13 February 2023

Project/File: 300304302

Reference: 7 City View Road, Pennant Hills – Response to Gateway Condition 1(c) and Transport for NSW (TfNSW) Request For Information

7 CITY VIEW ROAD, PENNANT HILLS NSW 2120
PLANNING PROPOSAL
LOADING DOCK
HIGH-LEVEL DESIGN ADVICE
DRAWING NO. 300304302-01-01 SHEET 01 OF 02 ISSUE P2

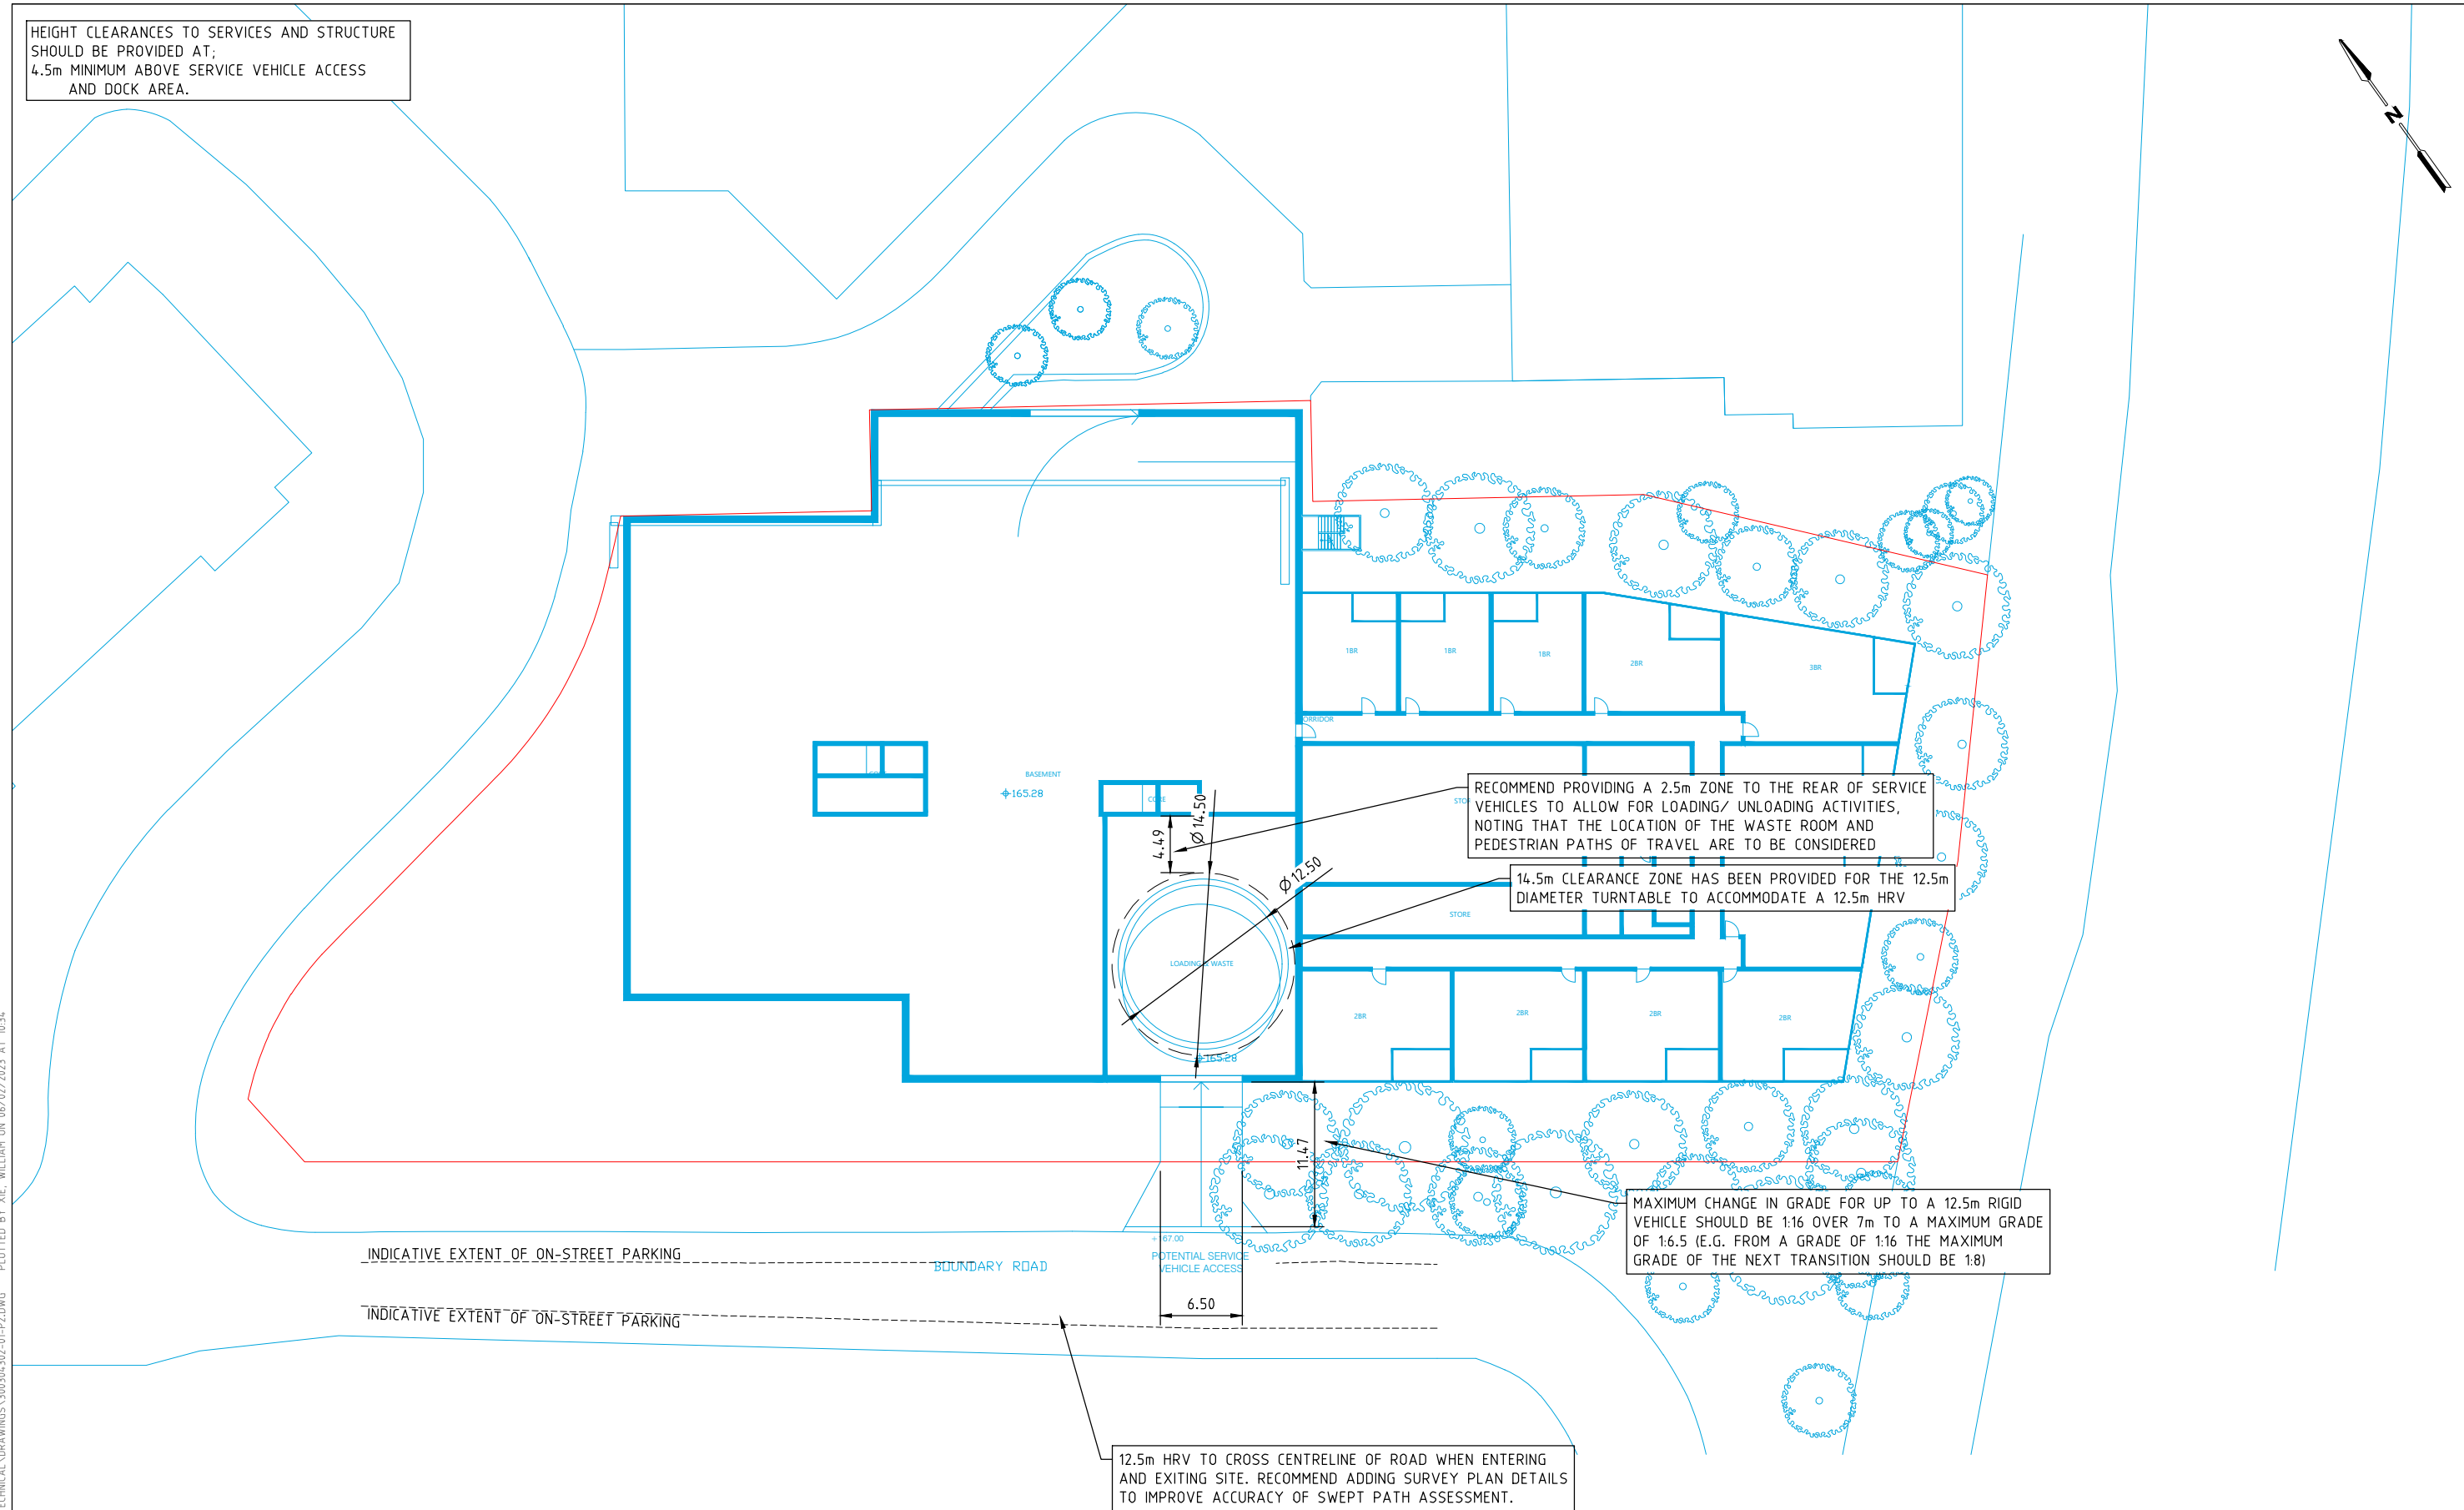
MAXIMUM CHANGE IN GRADE FOR UP TO A 12.5m RIGID VEHICLE SHOULD BE 1:16 OVER 7m TO A MAXIMUM GRADE OF 1:6.5 (E.G. FROM A GRADE OF 1:16 THE MAXIMUM GRADE OF THE NEXT TRANSITION SHOULD BE 1:8)

12.5m HRV TO CROSS CENTRELINE OF ROAD WHEN ENTERING AND EXITING SITE. RECOMMEND ADDING SURVEY PLAN DETAILS TO IMPROVE ACCURACY OF SWEEP PATH ASSESSMENT.

7 CITY VIEW ROAD, PENNANT HILLS NSW 2120
 PLANNING PROPOSAL
 LOADING DOCK
 VEHICLE SWEEP PATH ASSESSMENT
 DRAWING NO. 300304302-01-02 SHEET 02 OF 02 ISSUE P2

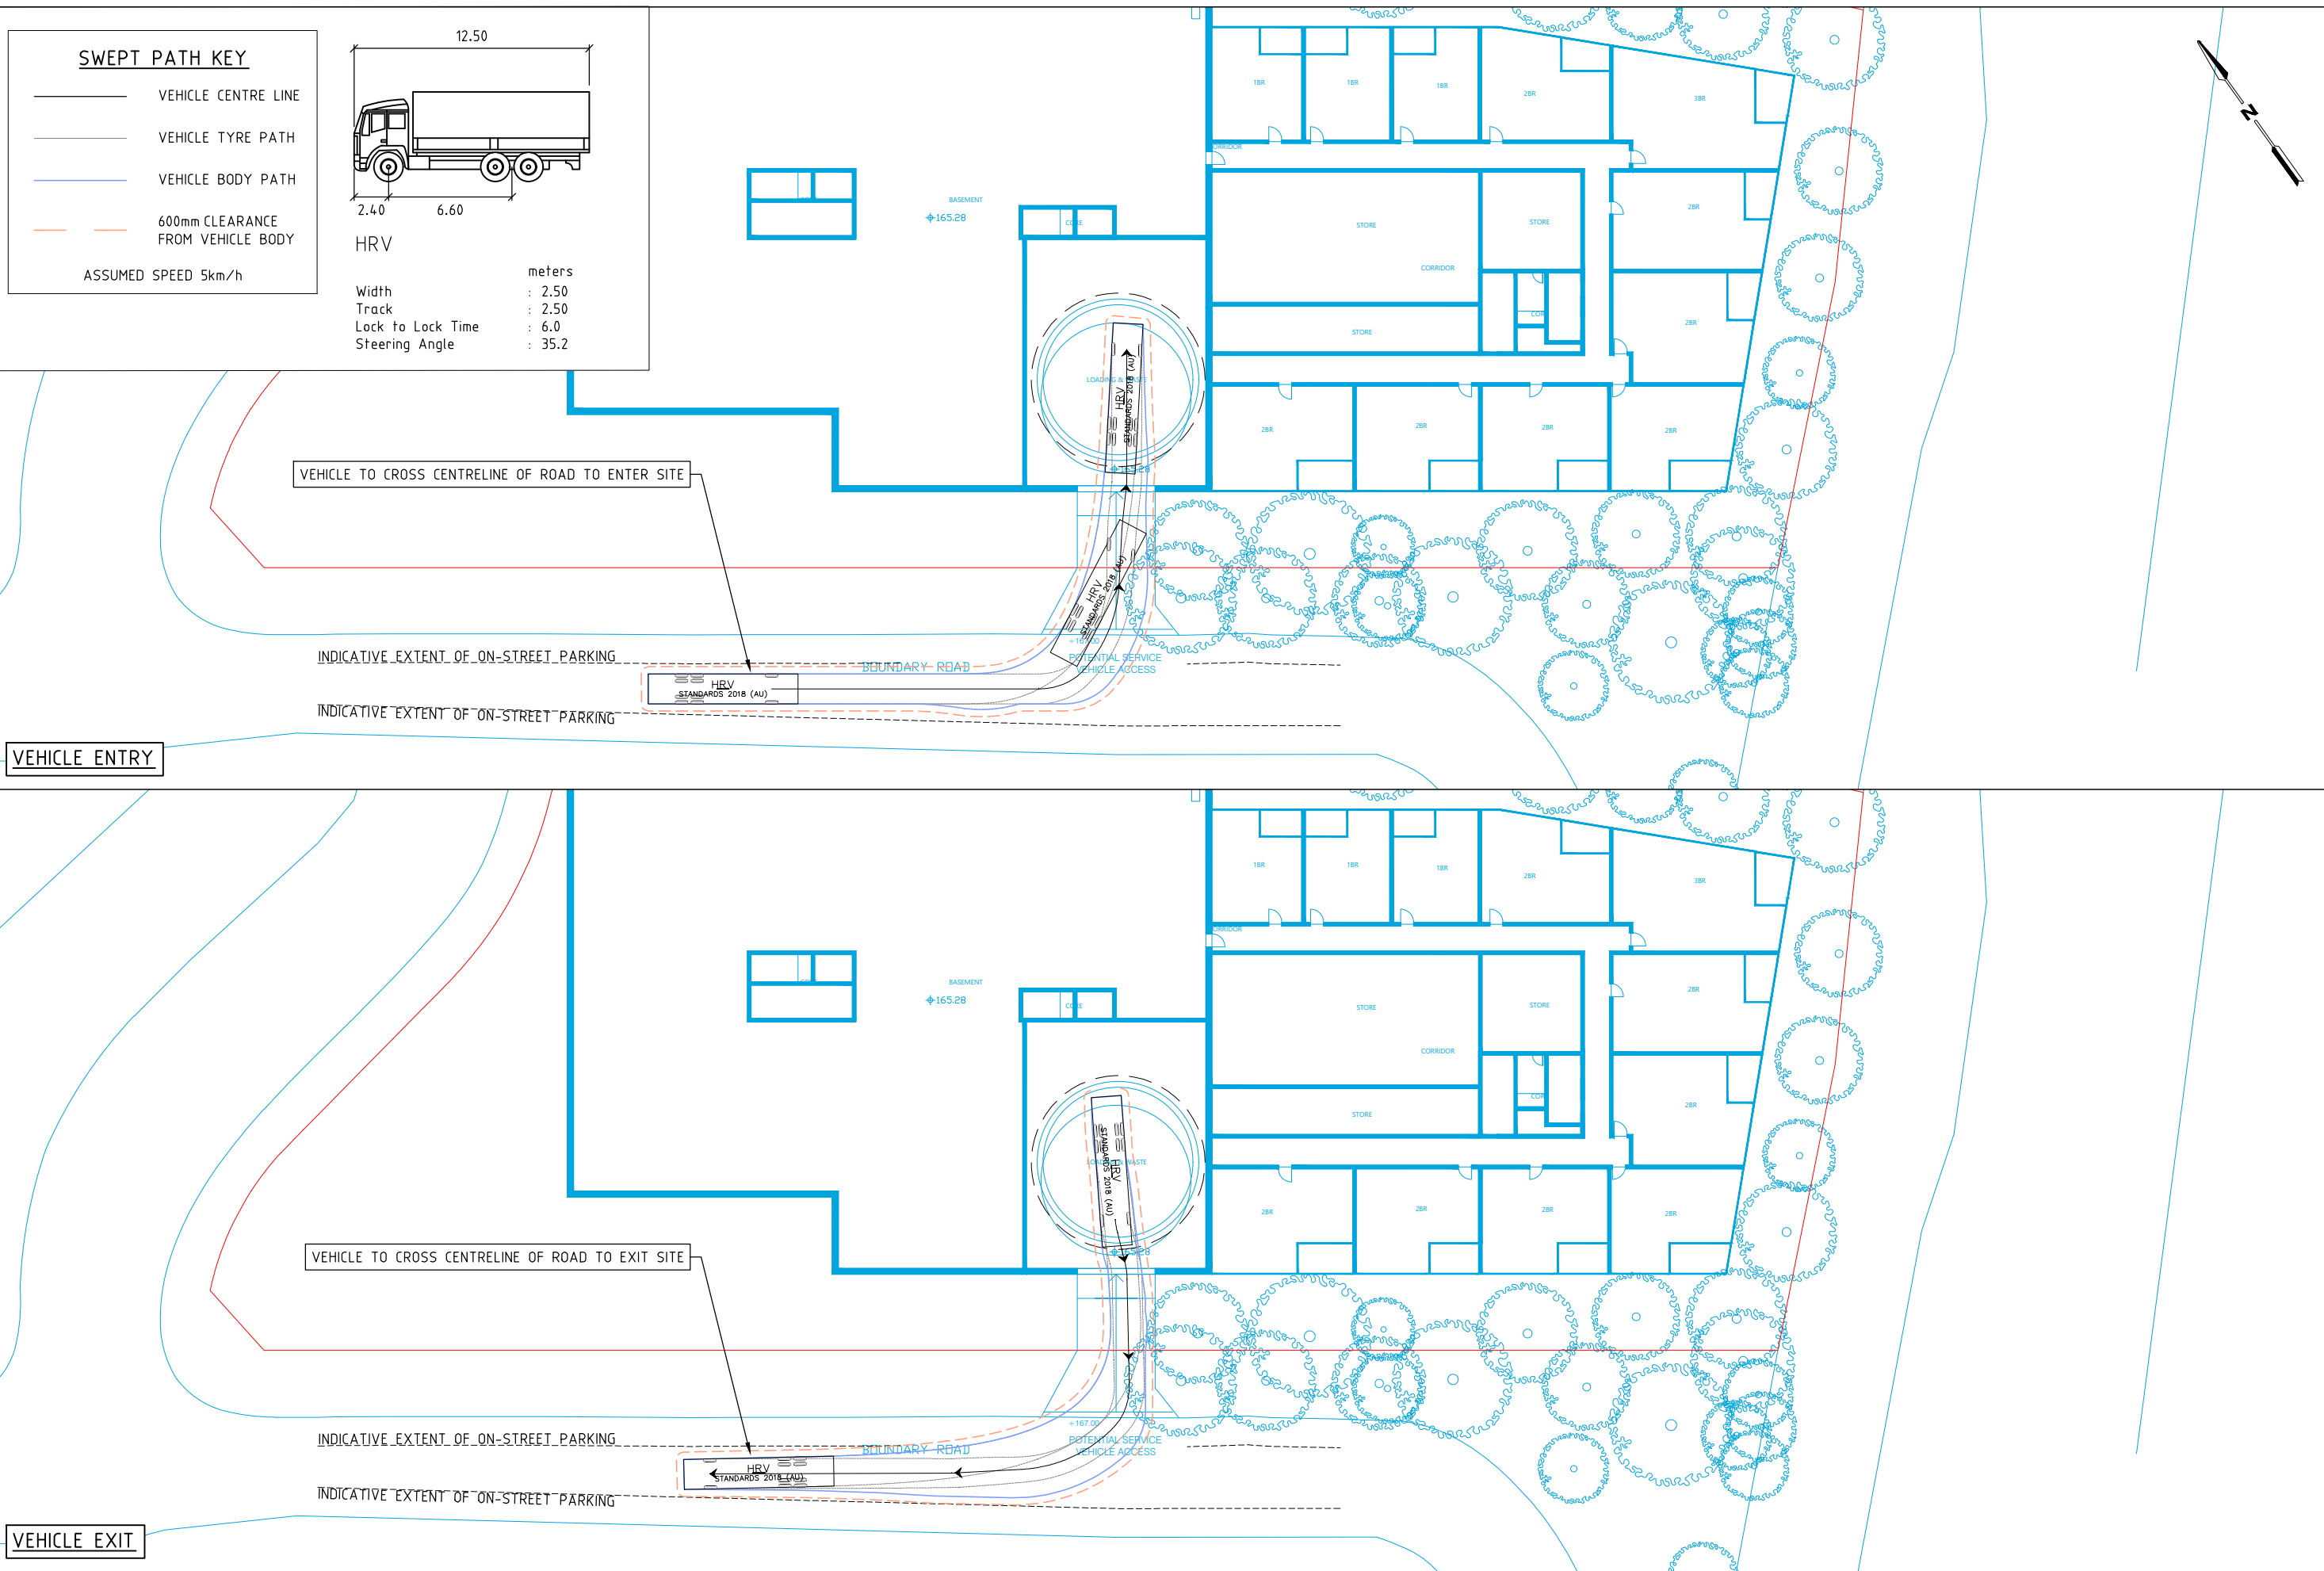
A swept path analysis is required for heavy vehicles to ensure heavy vehicles will be able to access the proposed service area. This applies to deliveries and rubbish collection services to ensure an appropriate vehicle can access the proposed location in a safe and convenient manner.

Swept path analysis has been undertaken using a 12.5m Heavy Rigid Vehicle which indicates that the vehicle is able to access the proposed service area using the designed access driveway. The proposal involves provision of a turntable which will assist with turning the vehicle to safely exit the site in a forward direction. Therefore, the proposed access driveway and service area arrangement is considered satisfactory.

The swept path analysis is provided in Attachment C.
